UNITED STATES PATENT AND TRADEMARK OFFICE

10/582,543

Office Action Summary	Application No. 10/582,543	Applicant(s) ANDERSSON ET AL.	
	Examiner Allen J. Flanigan	Art Unit 3744

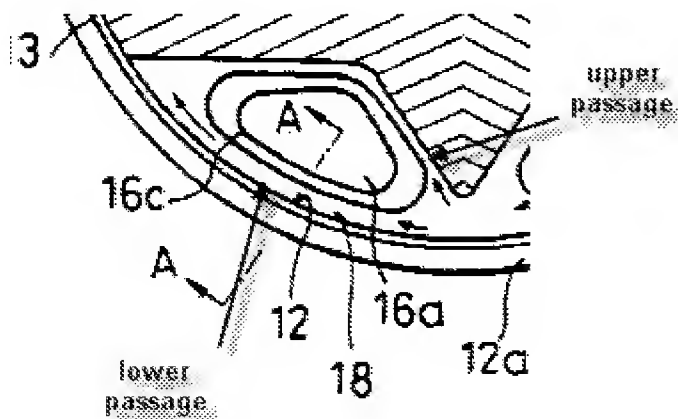
Yoshioka et al. show a stacked plate heat exchanger with plates brazed together to form interleaved passages for two fluids exchanging heat. The problem of stagnant flow near sealed off pass through ports for the other fluid is dealt with in much the same way as the claimed invention, i.e. by the provision of dual passages that encourage flow around the sealed port (see Figs. 3 and 4):

Although Yoshioka et al. employs the term “brazing” instead of “soldering” to refer to the means of joining the plates to each other, the terms are considered equivalent in that both refer to a fusion bonding process involving fusible alloys that have melting points lower than the material being joined. Regarding the claimed “ridges”, either the raised portions 10a, 12 shown in Fig. 4 and/or the terminal region of the herringbone ridged pattern of the plates would be readable on the claimed ridges, as these elements at least partially define the passages that surround the port 16a.
